<u>REMARKS</u>

AMENDMENT (09/904,663)

KAN 120D1

FIG. 29

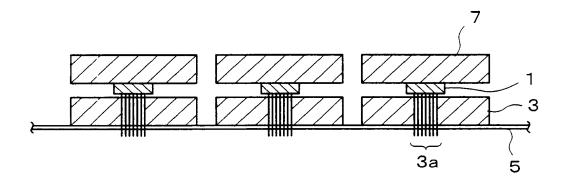
The Examiner requires that Figs. 29-33 be labeled "Prior Art." The required copies of these figures, marked in red with the change, are submitted herewith.
